Prepared Testimony of Emily Grubert and Ranajit (Ron) Sahu on Behalf of Sierra Club on
the Application of Southern California Gas Company for Approval of its Woody Biomass to
Methane Pilot Project (406G) (Errata) (Redacted)

Date: March 16, 2026

**PREPARED TESTIMONY OF EMILY GRUBERT AND RANAJIT (RON) SAHU ON
BEHALF OF SIERRA CLUB ON THE APPLICATION OF SOUTHERN CALIFORNIA
GAS COMPANY FOR APPROVAL OF ITS WOODY BIOMASS TO METHANE PILOT
PROJECT (904G)**

Figure 1: WBF Process Flow Diagram

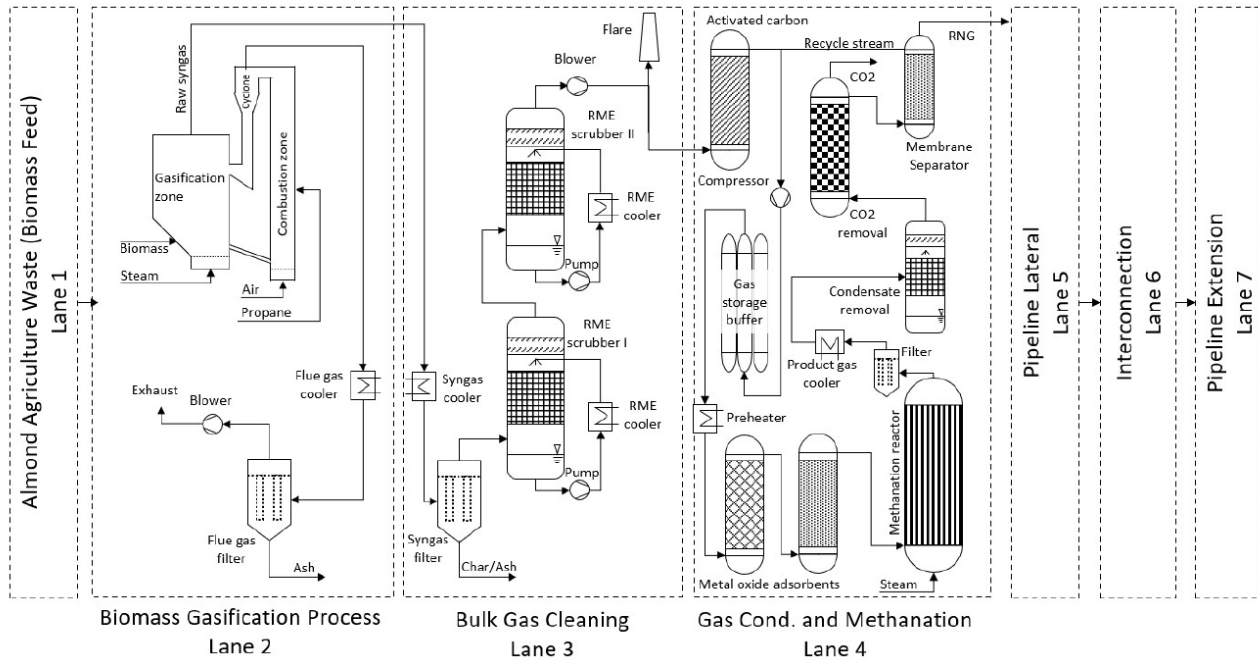
23 **A.** Based on what is shown in just Lanes 2-4 in Figure 1, as well as prior processing of the
24 biomass before it can be gasified and the steps after methanation up to pipeline injection,

11 **A.** It is my opinion that air pollutants will be emitted from the emission point noted as
12 “Exhaust” in Figure 1, Lane 2. Specifically, given the FICFB combustion zone, this
13 exhaust stream will contain a range of criteria pollutants, GHG, and combustion-
14 generated air toxics. Further, fugitive emissions of methane from various components in
15 this Lane, such as connectors, valves, pump seals, and storage devices, as indicated in
16 Figure 1 will also occur.

22 **A.** No, because, in my expert opinion, Response 3-2d to the Sierra Club states that this
23 exhaust will only contain NO_x and “criteria pollutants” alone. SoCalGas omits other
24 pollutants that, in my opinion, will be emitted including GHGs such as CO₂ and N₂O as
25 well as a range of combustion air toxics such as benzene, toluene, xylenes, hexane,
26 formaldehyde, and acetaldehyde, among others.

3 **A.** Emissions from Lane 3, gas cleaning, will consist of emissions from the “flare” indicated
4 in Figure 1 when the downstream methanation process cannot accept the syngas from
5 Lane 3. In my opinion, flaring of the syngas will produce a wide range of combustion-
6 generated pollutants including criteria pollutants such as NO_x, CO, PM_{2.5} as well as CO₂,
7 uncombusted methane, N₂O and also a range of air toxics such as benzene, toluene,
8 xylenes, hexane, formaldehyde, acetaldehyde, and others. Furthermore, as with Lane 2, it
9 is my opinion that there will likely be fugitive methane leakage from various components
10 in this lane such as connectors, valves, pump seals, and storage devices.

31 **A.** To the extent that preheating will be needed as contemplated by the existence of a
32 "preheater" (as indicated in Lane 4 of Figure 1), additional combustion-related emissions
33 may occur if combustion is needed to generate this heat. In my opinion, these

Further, as described in the record and as shown in Lane 4 on excerpted Figure 1 earlier, there will be fugitive emissions of methane and CO₂ from the Lane 4 processes. This air pollution fugitive leakage will occur from various components in this Lane such as connectors, valves, pump seals, and storage devices.

A. Since gases will flow through pipes and connections through this overall methanation Lane 3, fugitive emissions cannot be avoided due to leaking through connectors, valves, pump seals, and storage devices, as indicated in Figure 1. It is my opinion that the only way to avoid these fugitive leaks is to have specially designed components such as seal-less pumps, leakless valves, and the elimination of connectors (which, in my view, is practically impossible).

3 **A.** Based on my assessment, SoCalGas has not provided sufficient information about the
4 level and range of emissions that are going to occur as a result of the Project, including
5 NOx and other criteria pollutants from the Lane 2 “exhaust” and criteria pollutants from
6 the flare in Lane 3 as well as the numerous air toxics that will be emitted at least from
7 these sources within the proposed plant. In addition, as noted above, the emissions from
8 processing the feedstock and trucking the methane are not known nor are the quantities of
9 fugitive emissions from throughout the Project lanes, as explained above.
